TECHNICAL SPECIFICATION 3.4.6.2

ADDITION OF CHECK VALVES TO TABLE 3.4-1

A. DESCRIPTION OF AMENDMENT REQUEST

**FSAR UPDATE**  
**UNIT 1**  
**DIABLO CANYON SITE**  
 FIGURE 3.2-09 (Sheet 5 of 10)  
 PIPING SCHEMATIC  
 SAFETY INJECTION SYSTEM

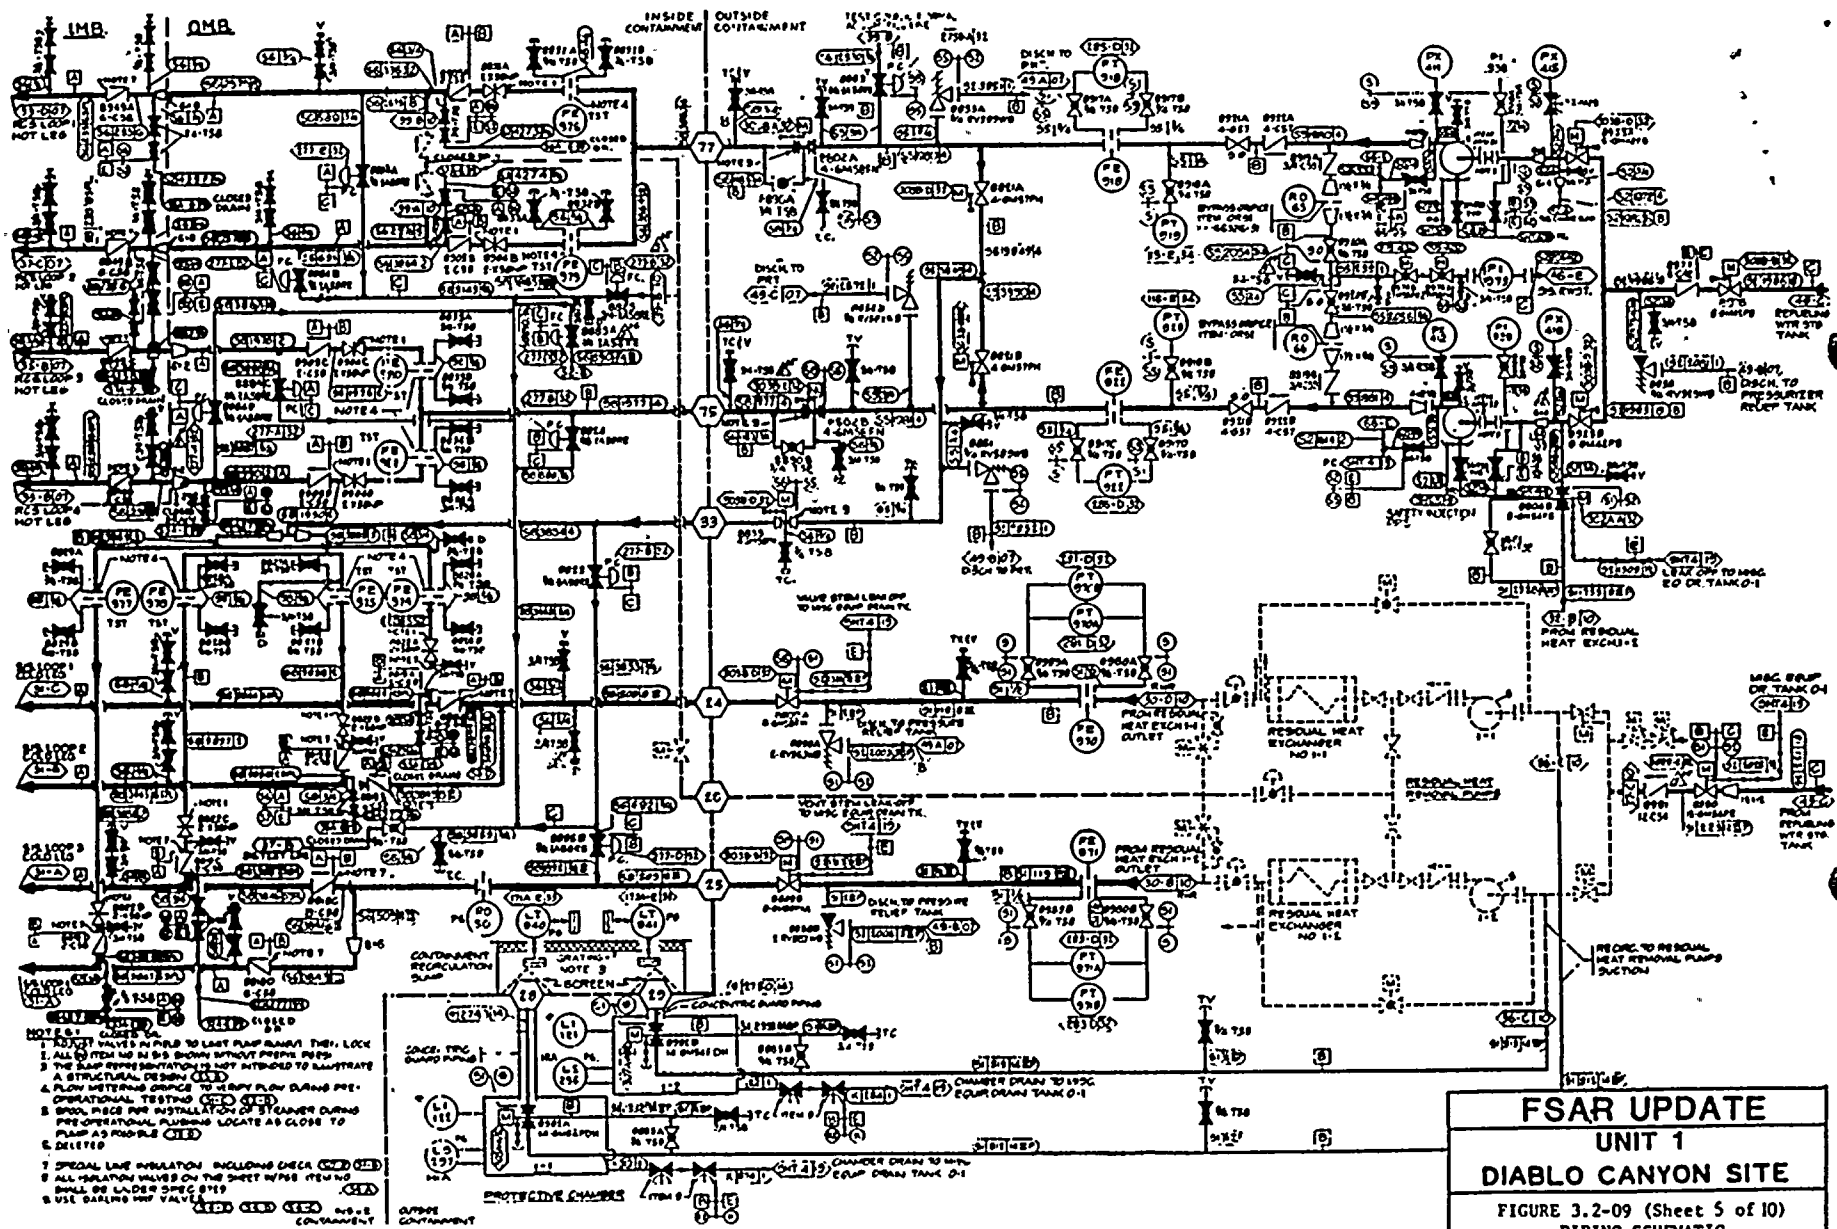
Attachment C contains the system drawings as requested by the NRC Staff showing the location of the valves to be added to Table 3.4-1 of Specification 3.4.6.2.
